MFN 220-95
Docket STN 52-004

Subject: **SBWR - Revised Drawings for PANTHERS Test Program**

- Attachments:
1. *PANTHERS-PCC VENT LINE*, SIET drawing 24.02.28, Revision 3.
 2. *PANTHERS-IC TEST FACILITY P&ID*, SIET drawing 24.01.00.DD, Revision 4.

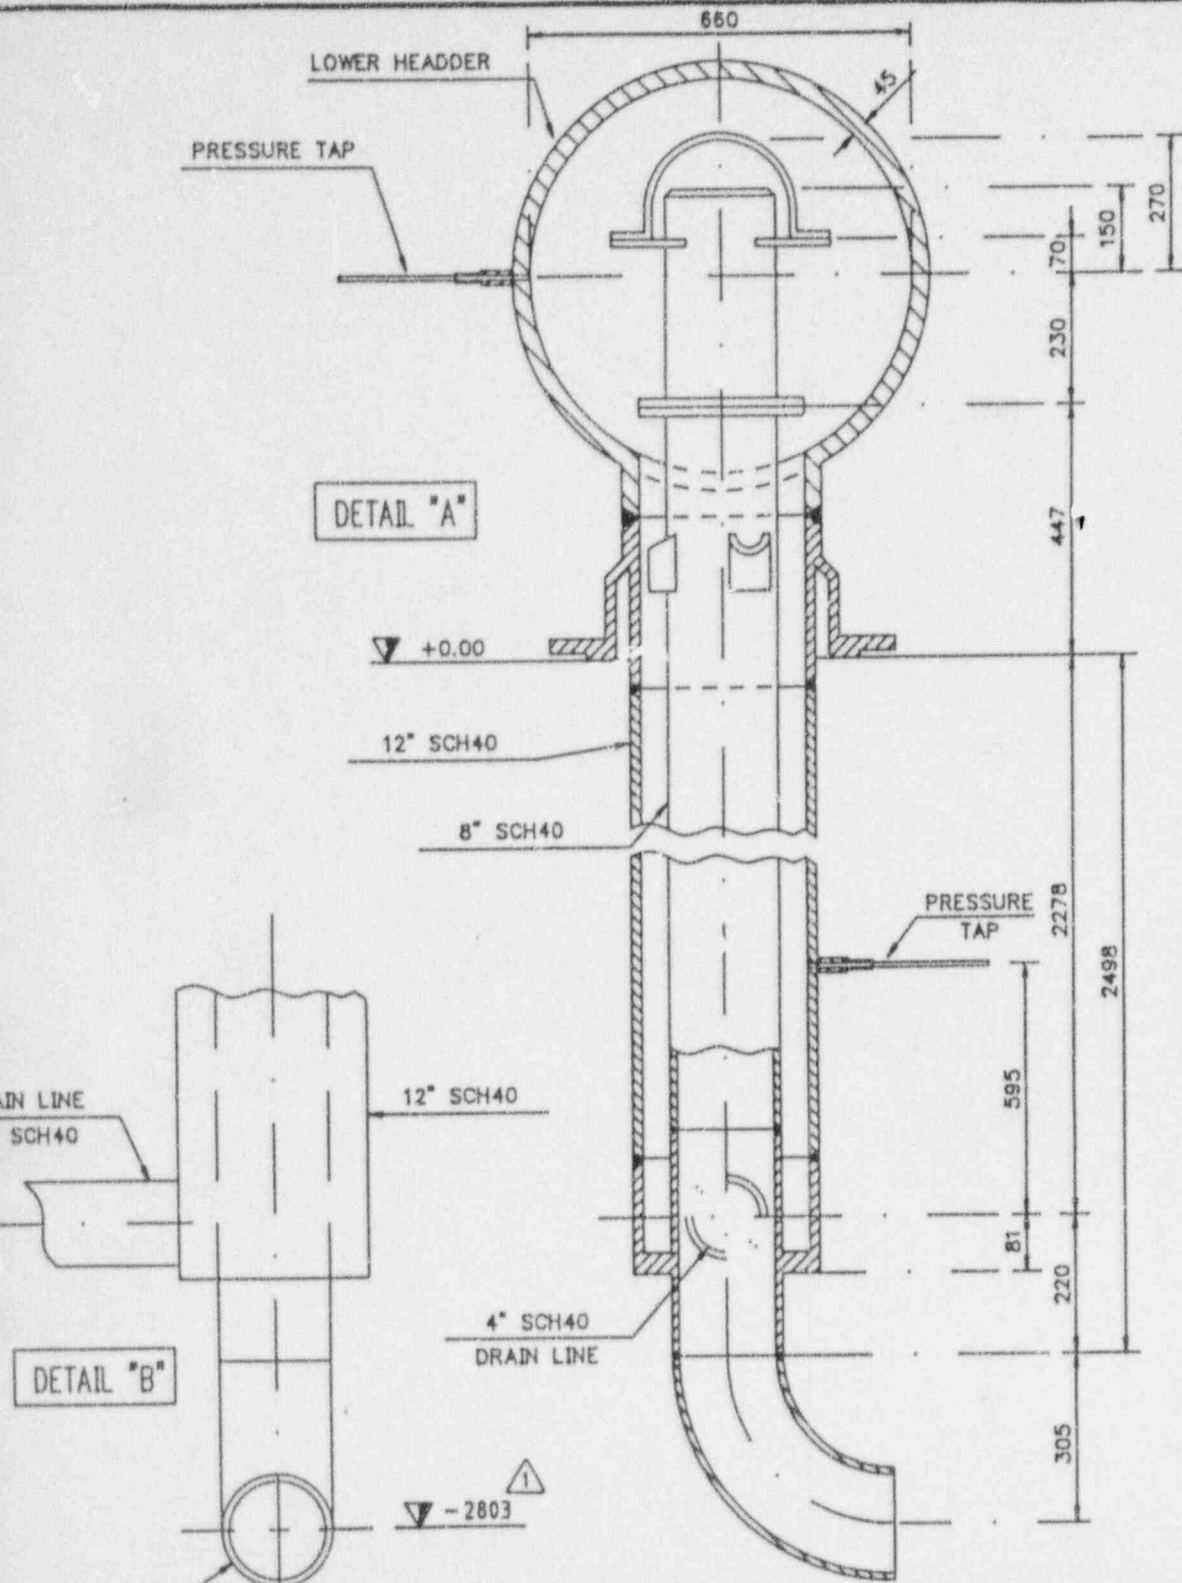
This letter provides revisions to two of the drawings associated with the PANTHERS test program. The PANTHERS-IC P&ID has been revised from that sent in Reference 1 to include recent changes in the test facility. The PANTHERS-PCC Vent Line as-built drawing has been revised from that sent in Reference 2 to correct a minor error found in the drawing. Areas of change are indicated on both drawings.
